Re: Tuthill Transport Technologies Recall No. 0509-Certain models 20/22 AR and RS 3162 Trailer Suspensions

Subject: Tuthill Transport Technologies Recall No. 0509 – Certain Models 20/22 AR and RS3162 Trailer Suspensions – Beam/Axle Pivot Connection Joint

49 CFR PART 573 - DEFECT INFORMATION REPORT
TUTHILL TRANSPORT TECHNOLOGIES RECALL NO. 0509 - CERTAIN MODELS 20/22 AR AND RS3162
TRAILER SUSPENSIONS - BEAM/AXLE PIVOT CONNECTION JOINT

GREAT DANE UPDATE KIT # K705979				
ITEM NO.	PART NUMBER	DESCRIPTION	QTY. PER PIVOT CONNECTION	QTY. PER KIT
1	23286-02	BOLT, 7/8-14UNF-2A x 7.5 LONG, GRADE 8	1	4
2	T-7292	WASHER (7/8)	1	4
3	23952-01	DISC SPRING WASHER (7/8 ID)	1	4
4	14345-01	LOCK NUT - 7/8-14UNF-2B, CLASS C	1	4

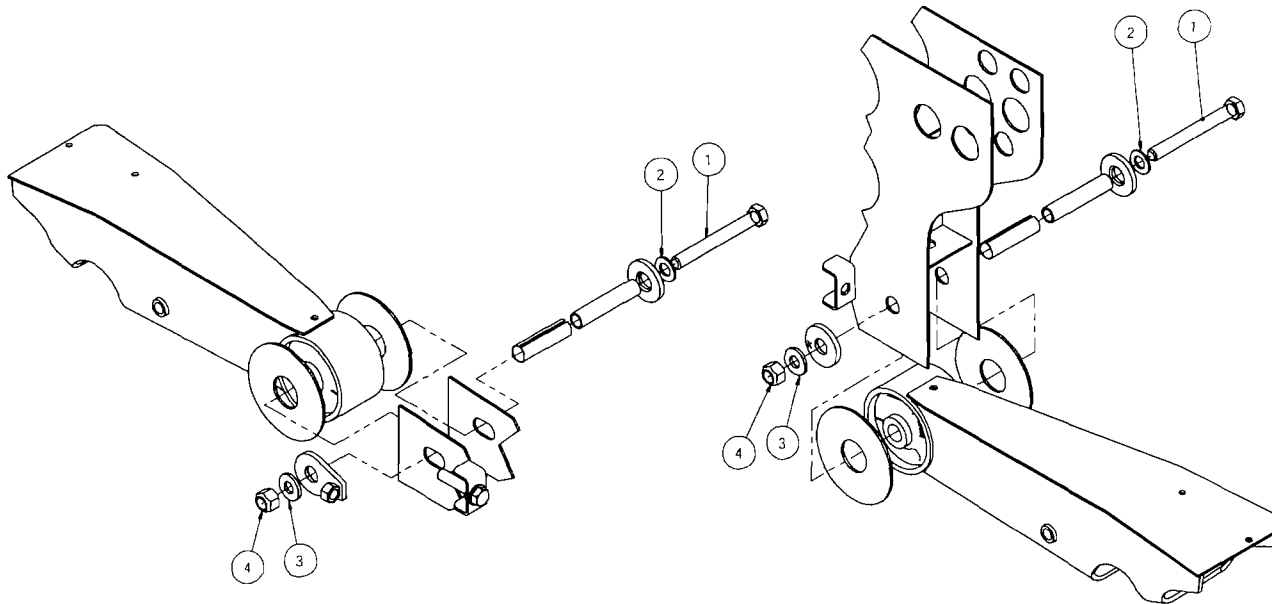
- Service Procedure: Tuthill Transport Technologies will dispatch trained personnel to dis-assemble and then re-assemble the beam/axle pivot connection. We will use a chamfer on the Rey-Align® washers and Rey-Align® Assemblies to retrofit the assembly of the beam/axle pivot connection joint. All units will be "reworked," (Exhibit B) and those needing further work will be "repaired." (Exhibit C). A separate remedy will be utilized for Great Dane trailers. (Exhibit D).

NOTE: ONE UPDATE KIT REQUIRED PER SUSPENSION

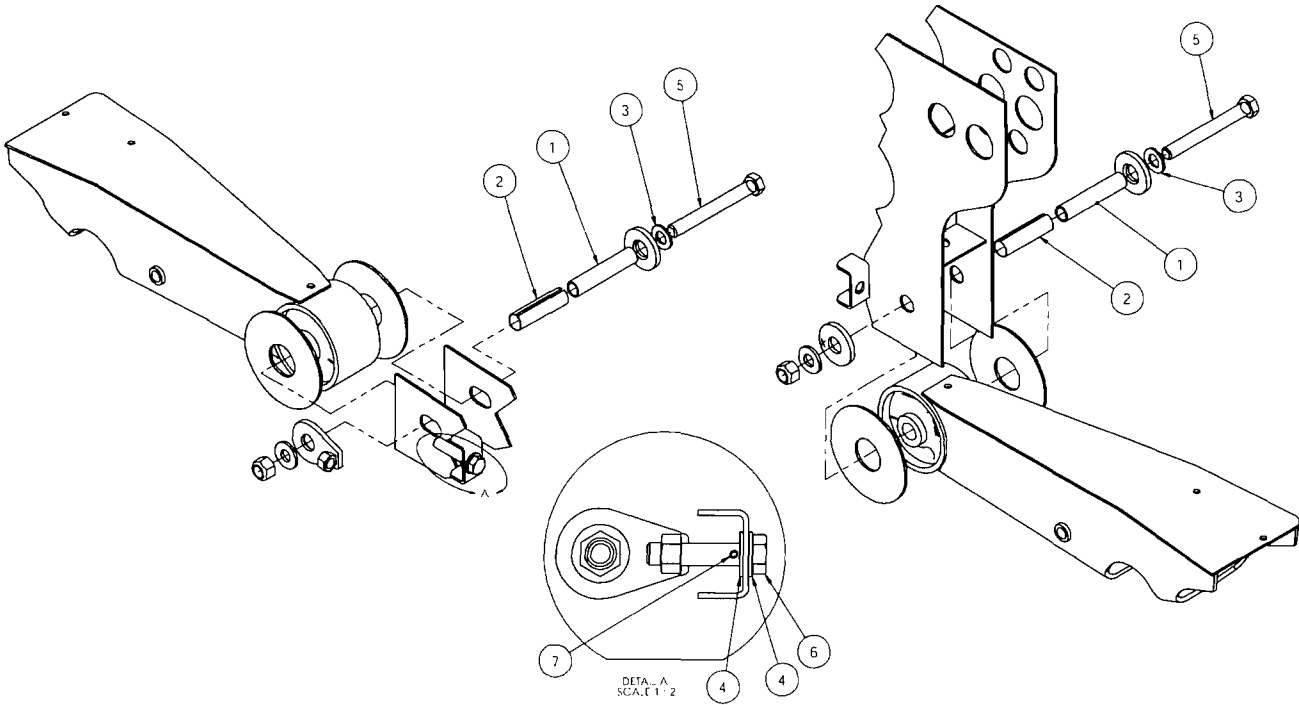
All units will be "reworked," (Exhibit B) and those needing further work will be "repaired." (Exhibit C). A separate remedy will be utilized for Great Dane trailers. (Exhibit D). To achieve this, Tuthill Transport Technologies is deploying sixteen teams equipped with parts and tools to rework or repair as required all units at:

REPAIR KIT # K705970			
ITEM NO.	PART NUMBER	DESCRIPTION	QTY. PER KIT
1	23674-02	PIVOT SHAFT TUBE	2
2	23432-02	SLEEVE COVER (4.375)	2
3	T-7292	WASHER (7/8)	2
4	20852-01	WASHER (3/4)	2
5	23286-02	BOLT - 7/8-14UNF-2A x 7.5 LONG, GRADE 8	2
6	24398-01	REY-ALIGN ADJUSTMENT SHAFT	1
7	24453-01	COILED SPRING PIN	1

NOTES: 1) FOR REPAIR, REWORK KIT K705971 IS ALSO REQUIRED
 2) ONE REPAIR KIT REQUIRED PER AXLE

REWORK KIT # K705971

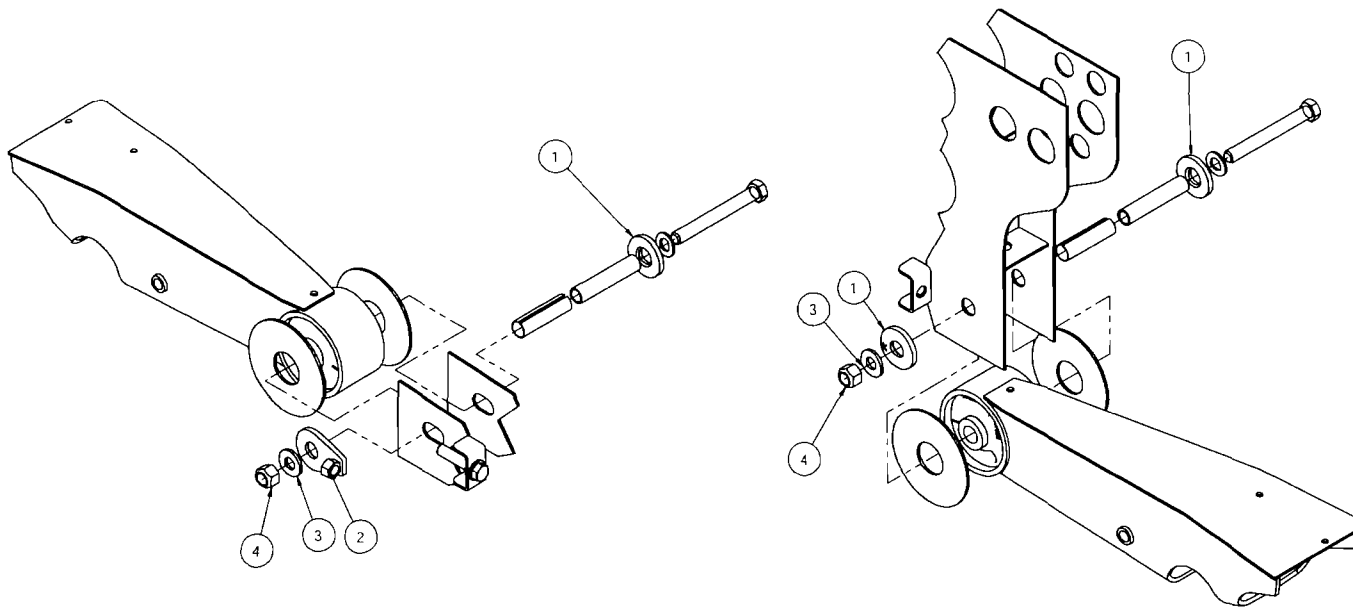
- Rework each unit with the new chamfered washer, a chamfered Rey-Align[®] Assembly and Rey-Align[®] washer, with the goal to retrofit, as possible, every beam/axle pivot bolt connection joint (4 per unit) by March 31, 2006;
- Repair all parts associated with the beam/axle pivot bolt connection joint that show signs of wear by March 31, 2006; and,
- Align all units immediately subsequent to the rework or repair.

ITEM NO.	PART NUMBER	DESCRIPTION	QTY. PER PIVOT CONNECTION		QTY. PER KIT
			ADJUSTABLE	NON-ADJUSTABLE	
1	23656-02	REY-ALIGN FLANGE WASHER	1	2	6
2	23673-02	REY-ALIGN ASSEMBLY	1	0	2
3	23952-01	DISC SPRING WASHER (7/8 ID)	1	1	4
4	14345-01	LOCK NUT - 7/8-14UNF-2B, CLASS C	1	1	4

NOTE: ONE KIT REQUIRED PER SUSPENSION

EXHIBIT A

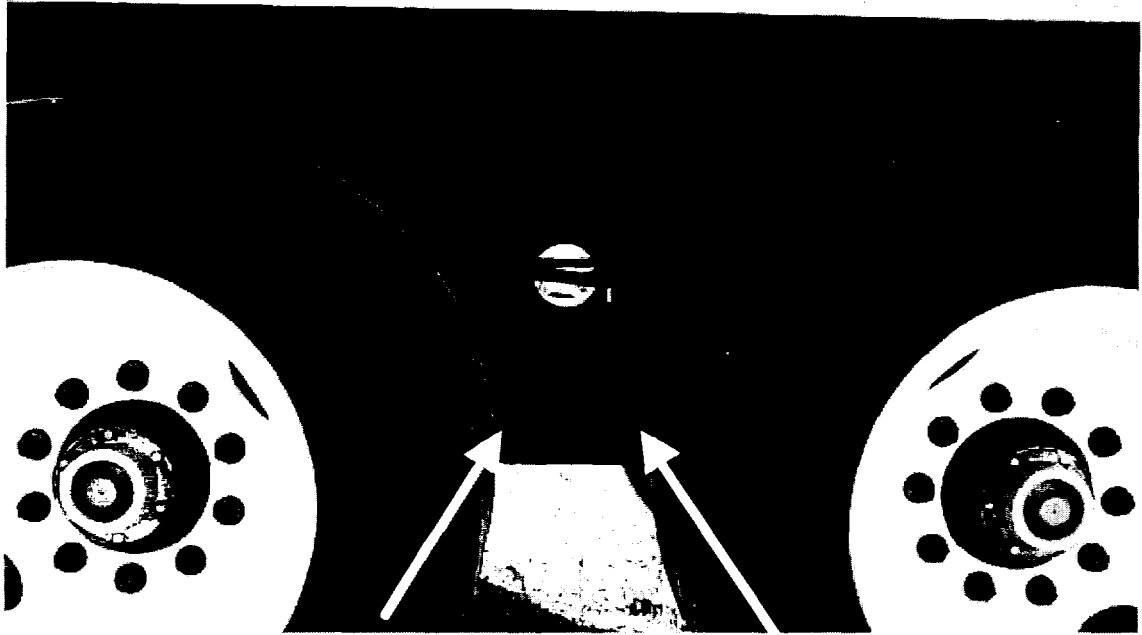
A mis-assembled beam/axle pivot connection joint will result in excessive play, which may be evident upon a visual inspection at any beam/axle pivot connection (Exhibit A). Also, this will especially be apparent during braking and acceleration. A truck driver will notice wandering of the trailer caused by mis-alignment of one axle to the other. The trailer suspensions shipped before and after those in the recall population do not suffer this potential condition.
